Access Compliance Report

Public Rights-of-Way

(Curb Ramps)

Intersection ID: 3670	Main Street: APPALOOSA_WAY_LN	Cross Street: CLAIBORNE_WOODS_RD	Location:	N
ADA ID: 3DAA6FA7ACAD	Ramp Type: Perp	Initial Pass/Fail: Fail	Overall Compliance: No	Severity Score: 10
Codes/Mitigation Info/Possible Solution		Field Measurements/Component Compliance

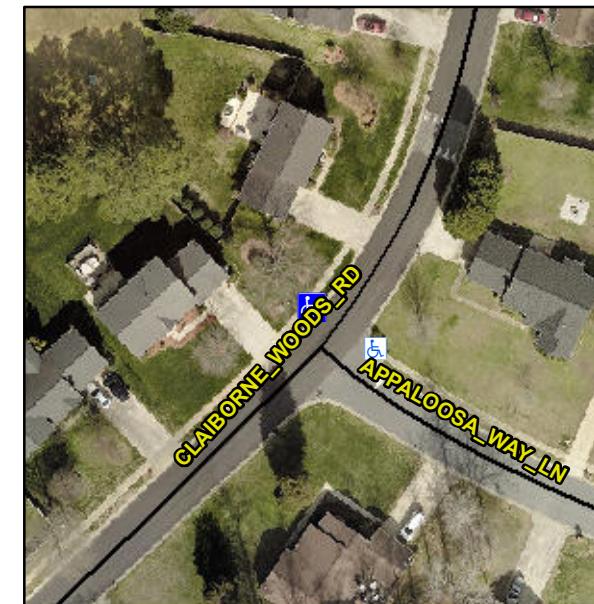
Not Found, R304.5.1, R304.5.3

Compliance	Description	Data	Compliance	Description	Data
N/A	Ramp Length (in)	47.0	Yes	Ramp Slope (%)	6.9
No	Ramp Width (in)	47.5	No	Ramp XSlope (%)	2.9
N/A	Flare Type LT	N/A	N/A	Flare Type RT	N/A
N/A	Flare Slope LT (%)	N/A	N/A	Flare Slope RT (%)	N/A
N/A	Flare Traversable LT?	N/A	N/A	Flare Traversable RT?	N/A
N/A	Landing Length (in)	N/A	N/A	DWS Provided?	N/A
N/A	Landing Width (in)	N/A	N/A	DWS Contrast?	N/A
N/A	Landing Slope (%)	N/A	N/A	DWS Length (in)	N/A
N/A	Landing X Slope (%)	N/A	N/A	DWS Full Width?	N/A
N/A	Landing Curb? (Y/N)	N/A	N/A	DWS Offset (in)	N/A
N/A	Shared Landing?	N/A			
N/A	Gutter Ponding?	N/A	N/A	Gutter Slope (%)	N/A
N/A	Gutter Lip Ht (in)	N/A	N/A	Gutter X Slope (%)	N/A
N/A	Painted X Walk1?	No	N/A	Painted X Walk2?	N/A
	X Walk 1 Direction	To SW		X Walk 2 Direction	N/A
N/A	X Walk 1 Width (in)	N/A	N/A	X Walk 2 Width (in)	N/A
	X Walk 1 Slope (%)	2.7		X Walk 2 Slope (%)	N/A
	X Walk 1 X Slope (%)	1.9		X Walk 2 X Slope (%)	N/A

Remove & Replace Entire Ramp.
